# SERVICE LETTER

No. 328

**SUBJECT: Lycoming Service Letter No. L126 dated January 29, 1960**

SUBJECT: Replacement of Guide Collars with New Forged Collars on Certain Non-Feathering Flange Mounted Propellers.

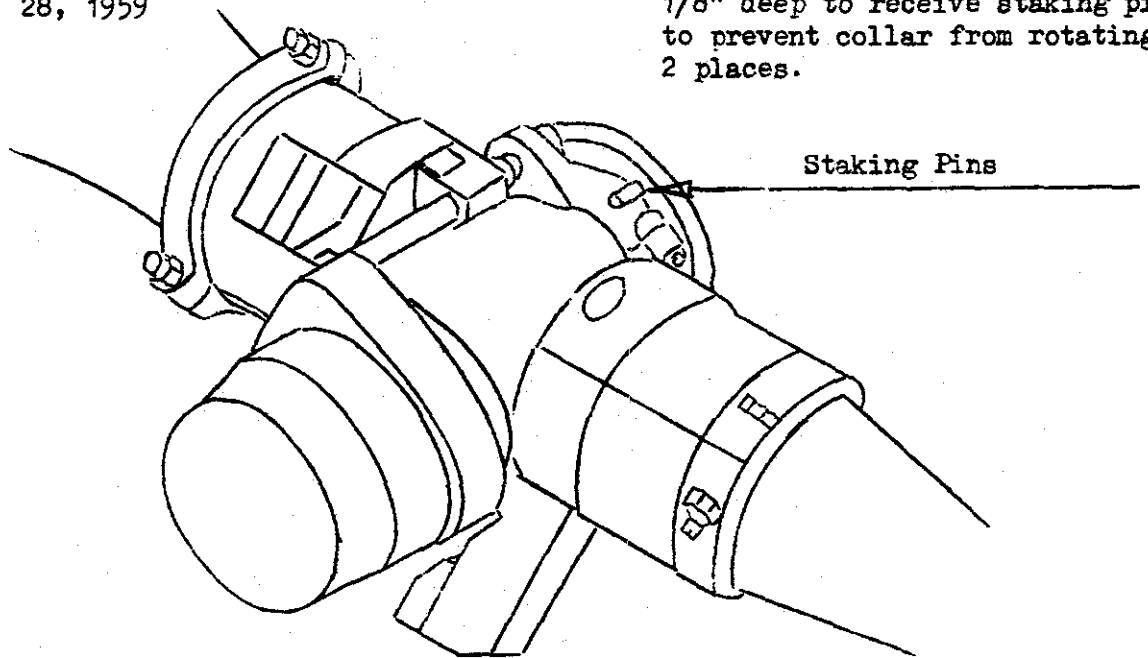
Replace the cast guide collar on these models affected by this bulletin with a forged collar as soon as convenient but not later than the next overhaul or January 1, 1961, whichever occurs first. Until the forged collar is installed, frequent visual inspections of the part is recommended. This can be done without removing the spinner, by looking through the spinner blade cut-outs. The cast parts which have been physically tested need not be inspected or replaced. These collars are marked with the letter "P". Forged collars are marked with the letter "F".

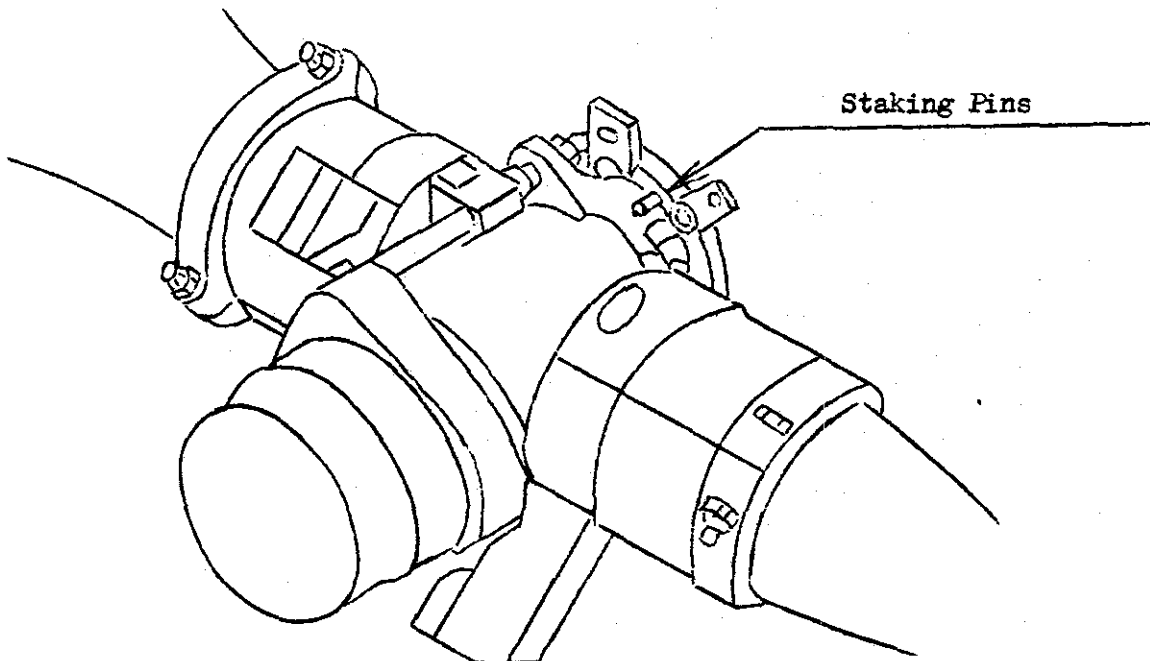
When the new collar is installed, it will be necessary to spot face the edge of the new guide collar thru the two dowel pin holes and reinstall the dowel pins as shown on Page 3.

After collar is properly located to receive piston guide rods, spot face edge of collar, approx. 1/8" deep to receive staking pins to prevent collar from rotating, 2 places.

First, install 4 spinner lugs, using new AN4E-4A bolts. After collar is properly located to receive piston guide rods, spot face edge of collar approximately 3/32" deep to receive staking pins to prevent collar from rotating, 2 places.

CAUTION!!! - For Model HC-82XF-1DB, the two steel dowel pins inserted in both the engine and propeller flanges are located 60° from the aluminum staking pins shown. BE SURE TO REPLACE THESE PINS. For the other models, the dowel pins also serve as collar staking pins.

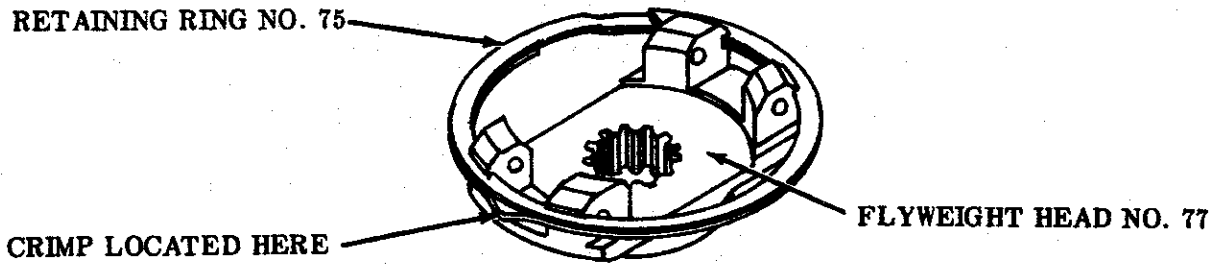
Proper installation of flyweight retaining ring (75), with the crimp down, in all CSSA and CSDA model governors.

To describe the proper installation of the flyweight retaining ring. Torsional vibration from the engine to the governor drive tends to cause relative rotation between the flyweight head (77) and the retaining ring (75). If the crimped leaf of the retaining ring climbs the chamfer on the lug of the flyweight head, the crimp will no longer be positively retained between the flyweight head lugs, and the retaining ring may be rotated out of the retaining ring groove. Removal of the retaining ring from the flyweight head releases the flyweight pins which causes the governor to be non-controlling, in addition to causing internal damage to the flyweight cavity of the governor body. Installation of the retaining ring, with the crimp down, prevents the crimped leaf from climbing out of the groove on the flyweight head lug.

**DETAILS** Retaining ring (75) must be installed on the flyweight head with the crimp of the retaining ring toward the thrust bearing surface and between the flyweight lugs as shown in Figure No. 1. Be sure that the retaining ring is properly seated in the groove. ALL GOVERNORS SO MODIFIED MUST BE STAMPED WITH S22 ON THE GOVERNOR NAMEPLATE.

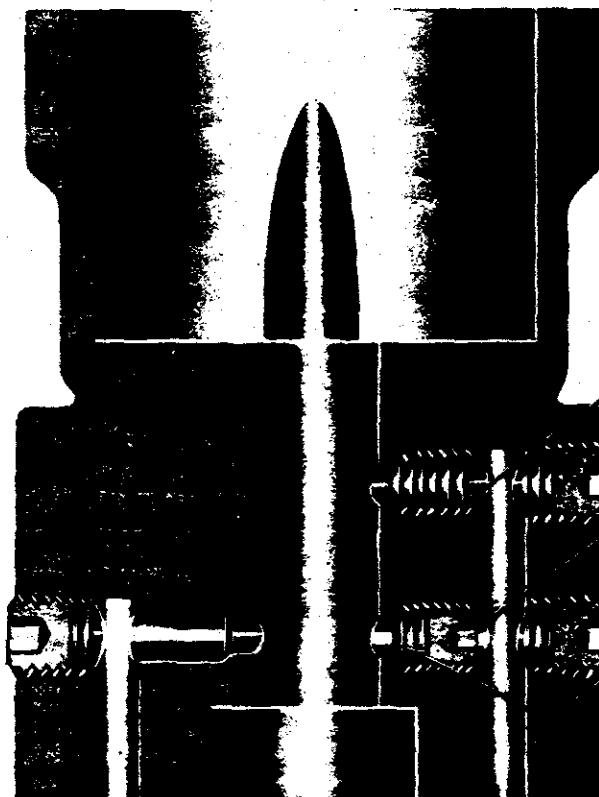
Governor body modification for changing propeller control pressure from decrease pitch to increase pitch.

All controls that have plug in upper passage, see below, supply propeller control oil to decrease pitch. In the event a change in propellers is made and the new propeller requires control pressure to increase pitch, the governor bodies should be reworked per instructions shown below.

REMOVE PLUG  
187824 FROM TOP  
HOLE AND

INSTALL IN  
BOTTOM HOLE

TAP 1/16-27 NPTF  
(DRYSEAL)

BASIC GAGE LINE  
TO BE .720 FROM  
THIS SURFACE.  
0 TO PLUS 2  
TURNS FROM BASIC.
